**COLLEGE PARK HIGH SCHOOL  
ATHLETIC FACILITIES IMPROVEMENTS PROJECT  
RESPONSE TO COMMENTS DOCUMENT**

STATE CLEARINGHOUSE NO. 2014042003

June 2014

FIGURE RTC-1

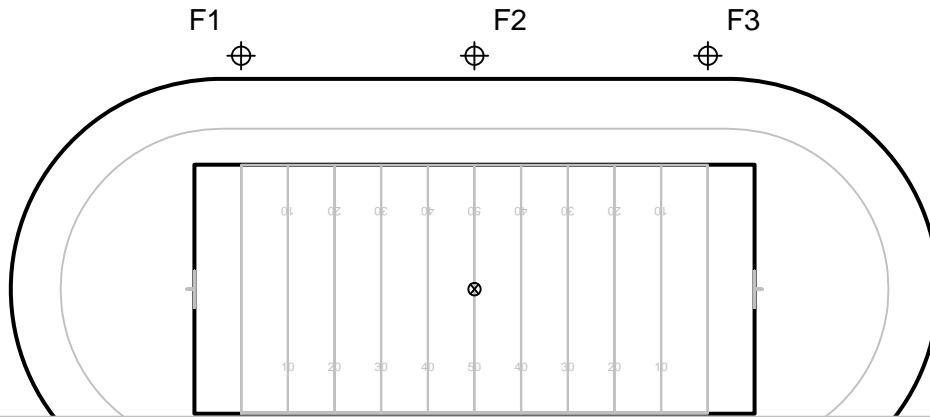
Where can I locate the lighting photometric report that details the light levels on the field and the surrounding area?

The lighting plan and summary in the appendix of the mitigated declaration package *exclusively* addressed the field, and not all the impacted homeowners. There were no drawings or documentation that addressed the impact to the homes and specifically the calculations for the lighting on each home's horizontal, and vertical surfaces, and most importantly, the direct glare from the luminaires themselves. Without this basic design package deliverable, MDUSD and its consultant cannot demonstrate that the "potentially significant" and "substantial" light and glare will be mitigated at all. This is especially disappointing given that the recommendation to properly address the lighting was made on more than one occasion.

Response B2-1: Illumination summary output sheets for the proposed project are located in Appendix A of the Draft IS/MND. An additional illumination summary, which shows the light levels on the field extending out towards the west, is reflected in Figure RTC-1. Refer to Response B4-3 for additional discussion related to this illumination summary.

- In addition, to provide additional support for the analysis, an illumination summary was prepared to depict the spill light that would radiate out from the proposed lighting fixtures, extending west towards the residential neighborhood, as shown in Figure RTC-1 on the following page. The summary shows that, at the nearest residential property line (which is approximately 10 feet west of the nearest light pole), spill light would be between 0.1 and 0.4 horizontal footcandles, which is well below the recommended maximum level of 1.0 footcandle for the residential area.
